ADDENDUM 1
RFB #17-0038
RONALD REAGAN BUILDING RENOVATION-FLOORS 4,5,6

**RONALD REAGAN BUILDING RENOVATION – FLOORS
4,5,6
Sedgwick County**

Prepared by:
Schaefer Johnson Cox Frey Architecture, Inc.

ADD #1
4TH FLOOR PLAN

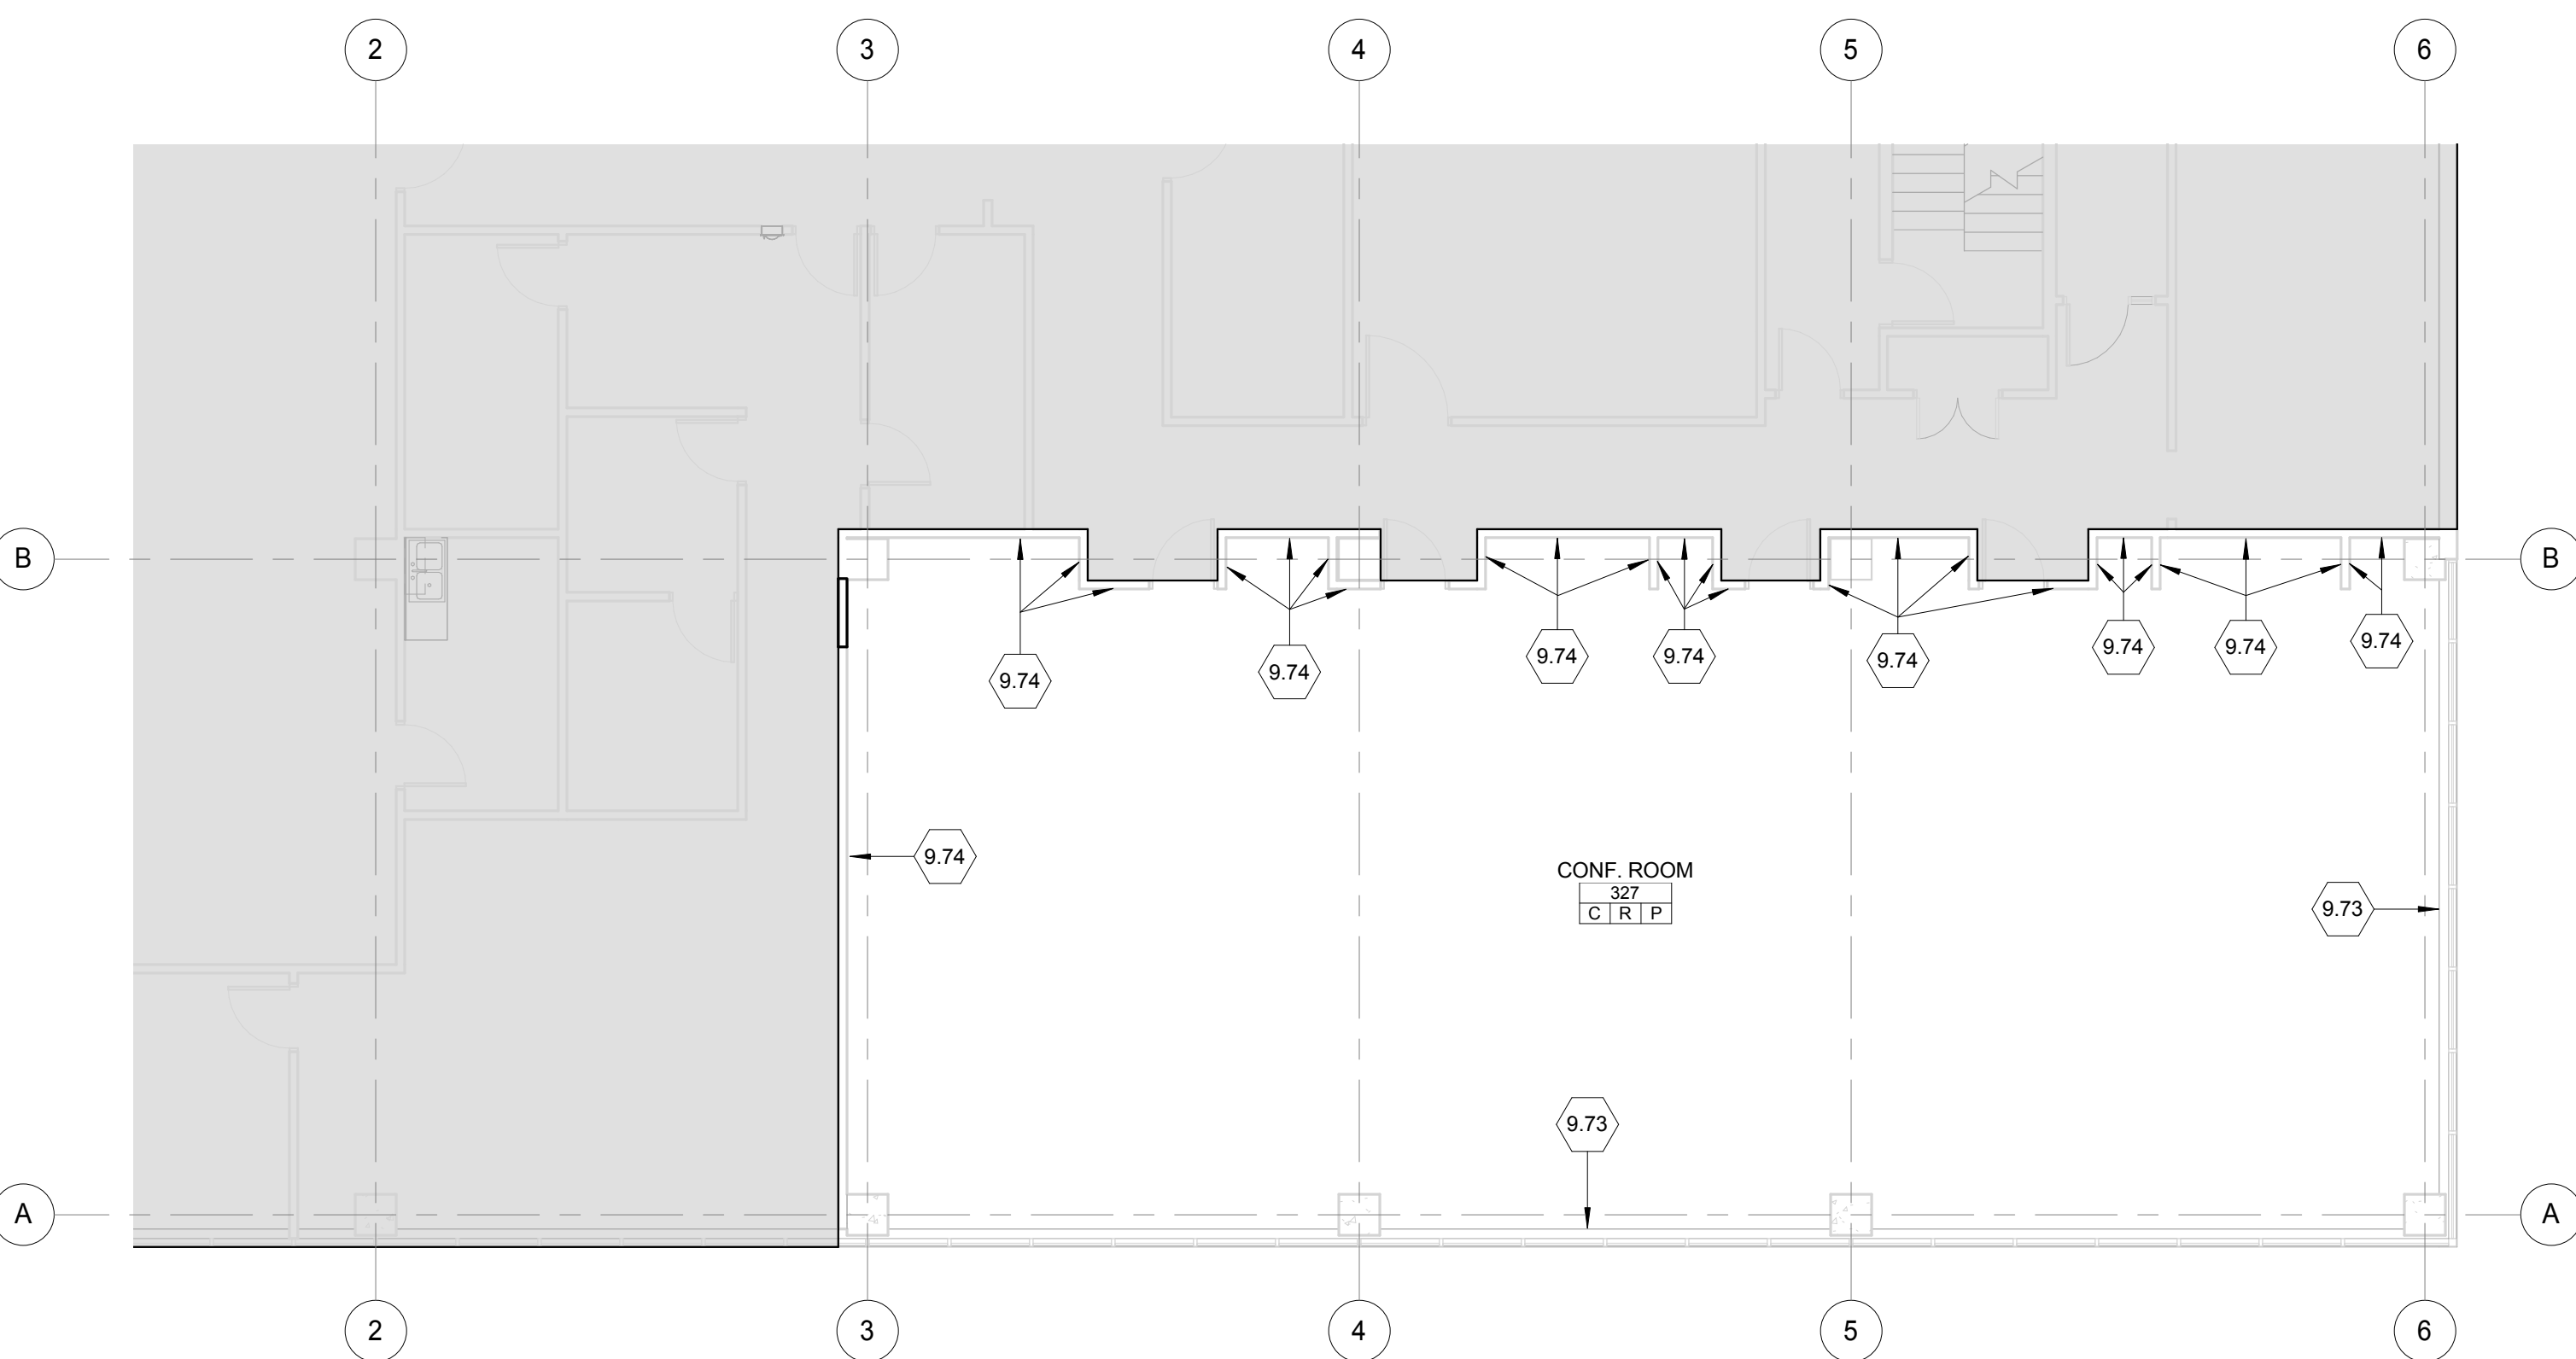
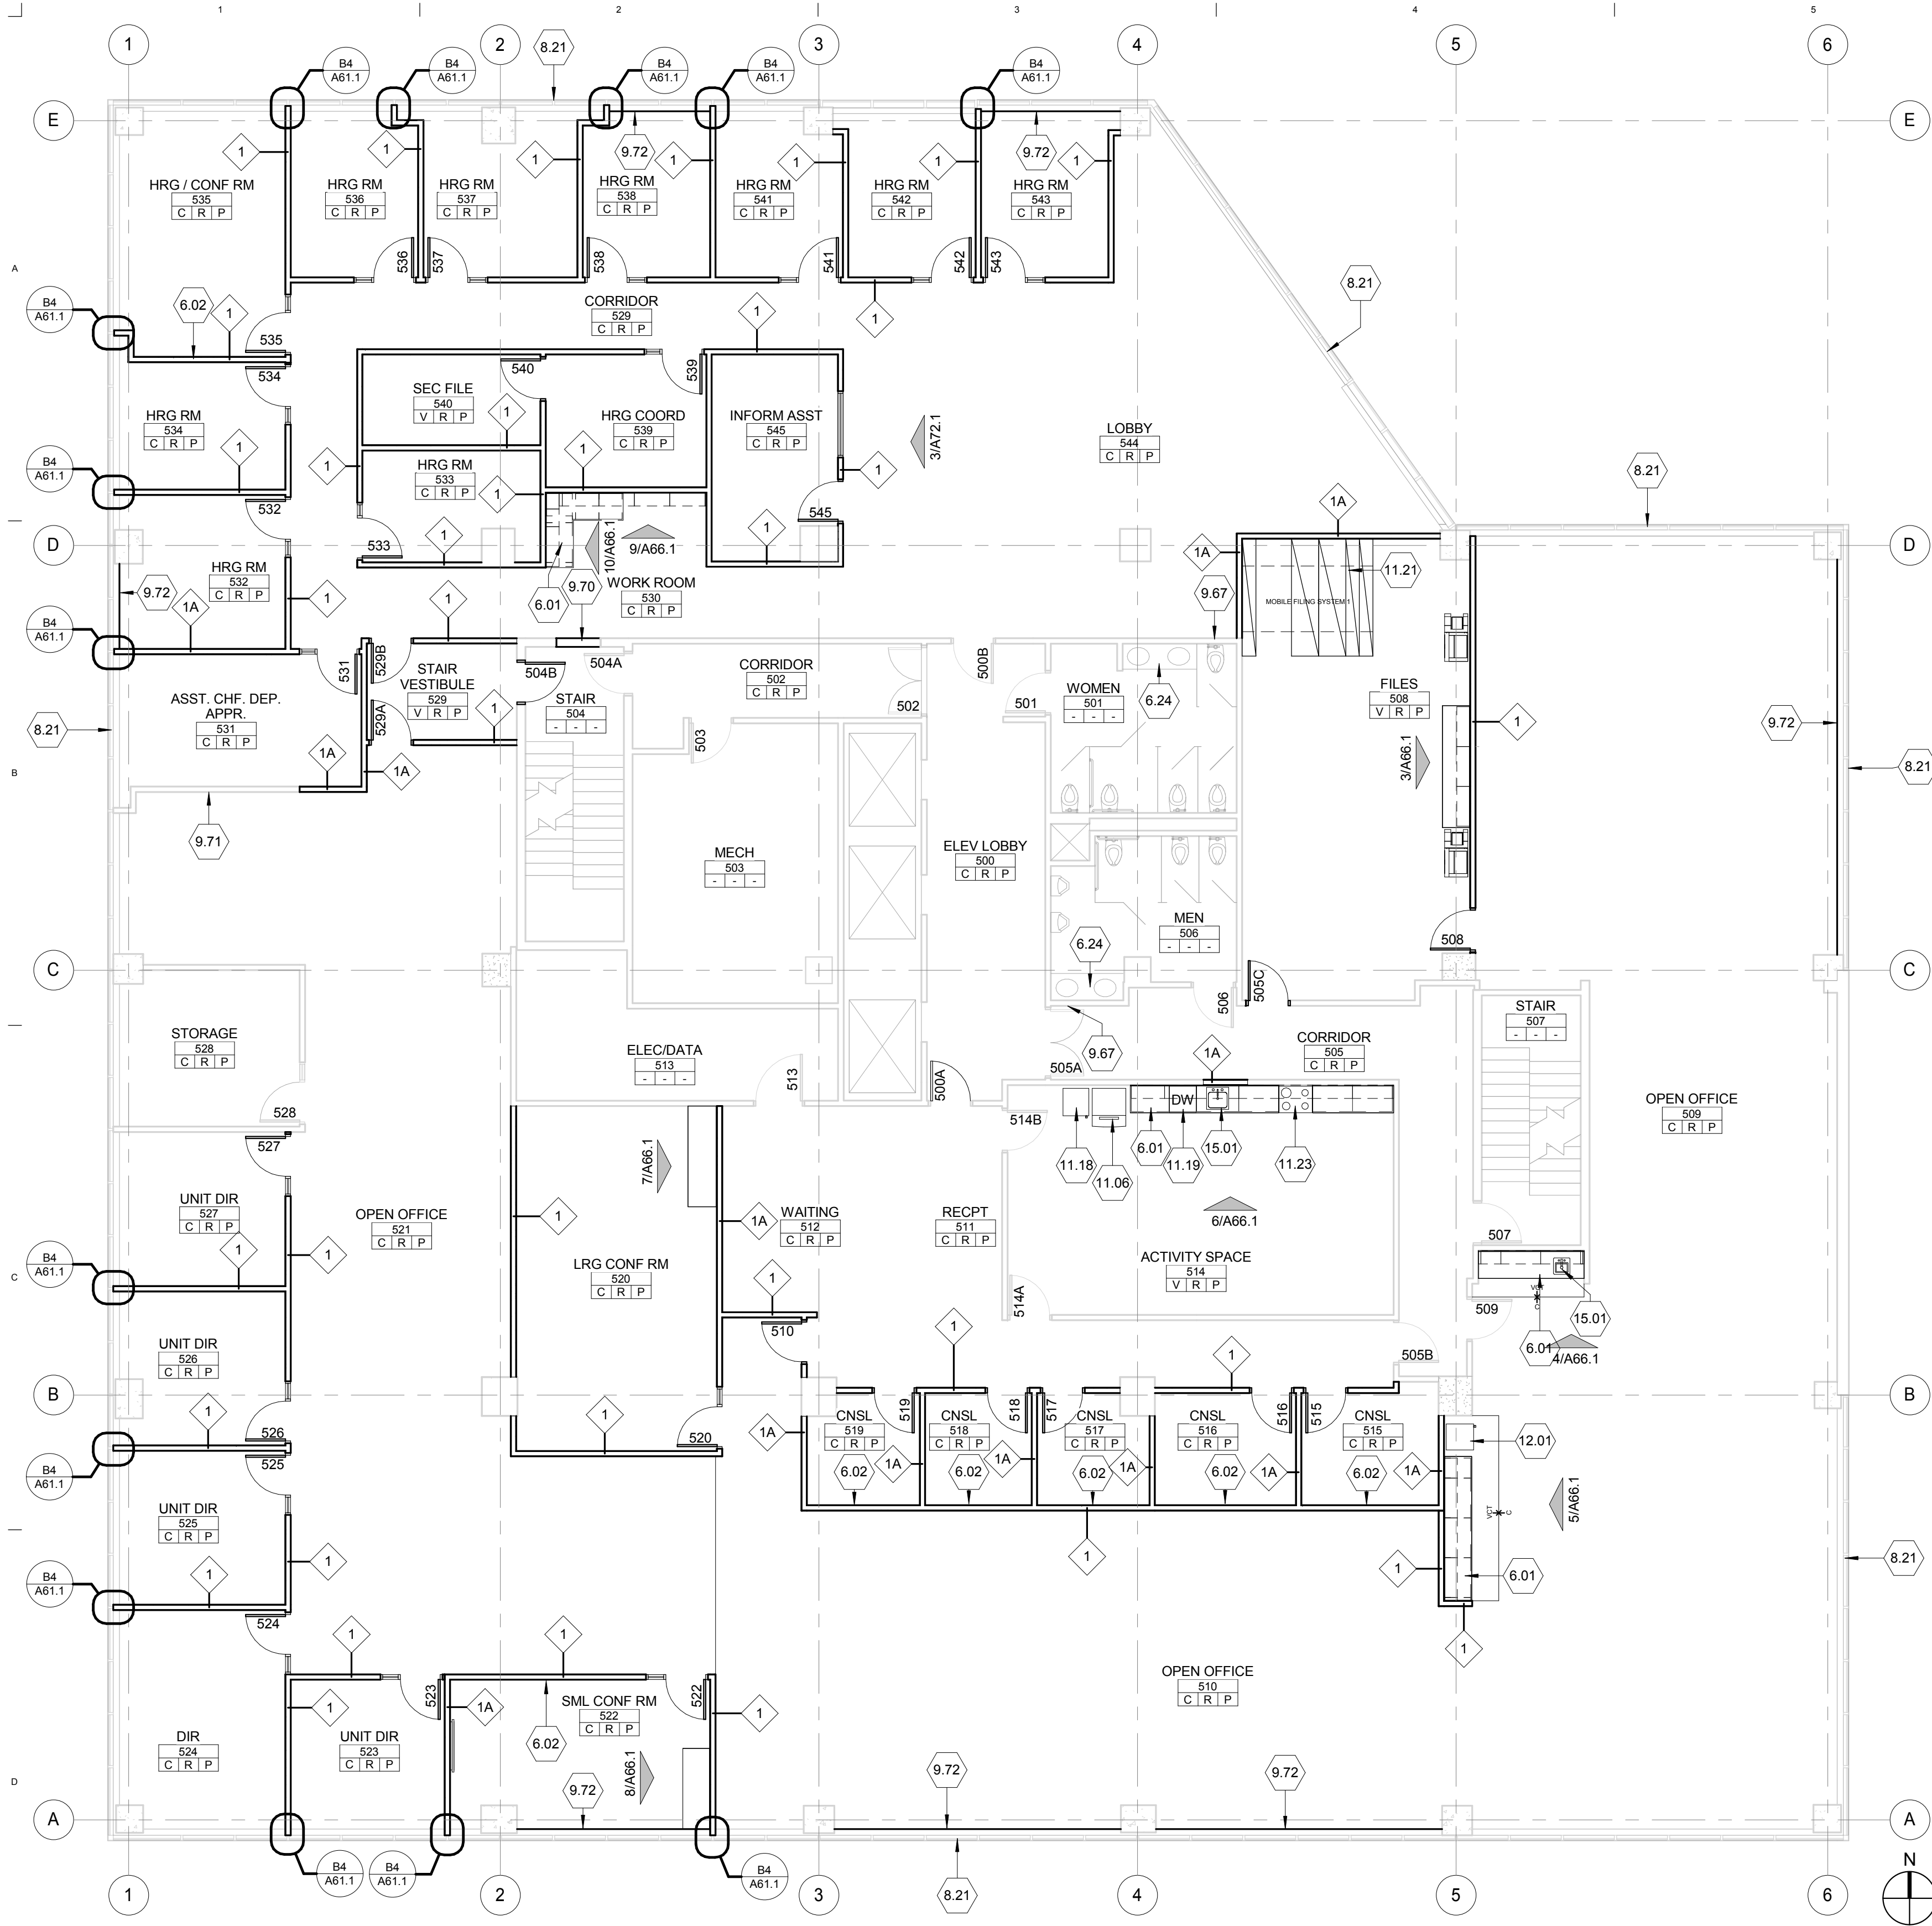
ITEM AD1-A04 DRAWING SHEET A22.1, KEYED NOTES:
REVISION Replace Keyed Note list per attached.
